RE: Preliminary Plan # 1-05081
Danshes Property

RE: Park Planning and Resource Analysis Unit's Conditions for approval
of Preliminary Plan #1-05081, Danshes Property

SUBJECT: Preliminary Plan 120050810, Danshes Property

SUBJECT: Preliminary Plan No. 120050810 (1-05081)
Danshes Property
Brooke Road
Rural (Patuxent) Policy Area

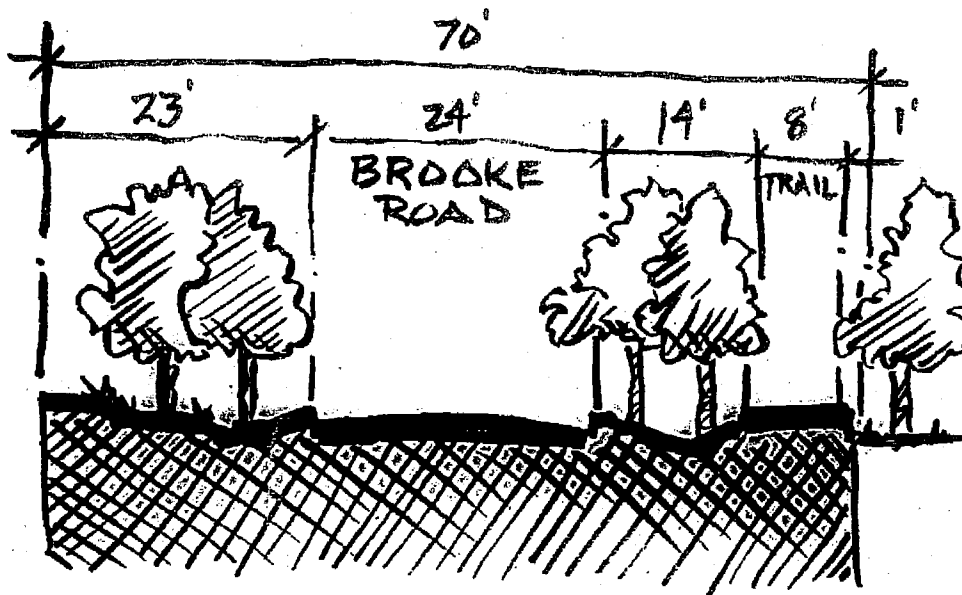
The cross-section shown below is recommended for Brooke Road. It features landscaping on either side of an 8' asphalt trail to create a sense of enclosure and to provide a natural setting.
